Technical Service Bulletin

97 Rattle noise from front right dash panel area

97 16 56 2042450/2 July 22, 2016. Supersedes Technical Service Bulletin Group 97 number 15-52 dated November 11, 2015 for reasons listed below.

Model(s)	Year	VIN Range	Vehicle-Specific Equipment
A6, A7	2011 - 2017	All	Not Applicable

Figure 1. Location of the wiring harness bracket.

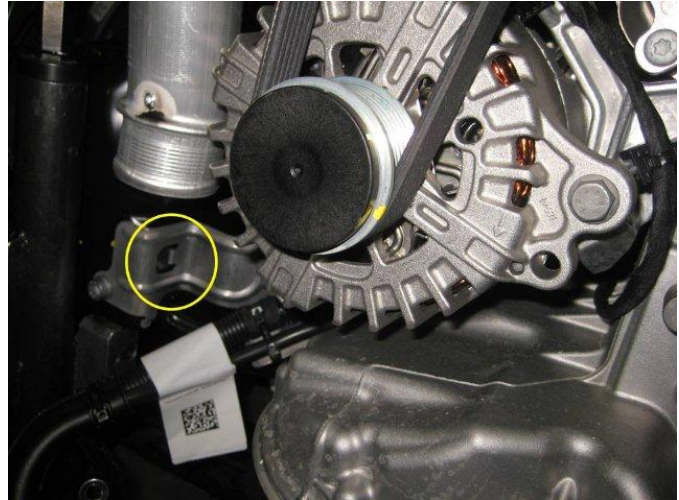
The bracket for the starter motor wiring harness has a locating tab that can vibrate.

1. Remove the bracket for the starter motor wiring harness. The bracket is located near the alternator (Figure 1).

2. Wrap a 3" piece of fabric adhesive tape (D 373125A2) around the locating tab to prevent it from moving freely (Figure 2 and Figure 3).

The tape should be wrapped around the tab approximately four times so that it fits firmly in the hole. There will be some resistance when the wrapped tab is put back in the hole.
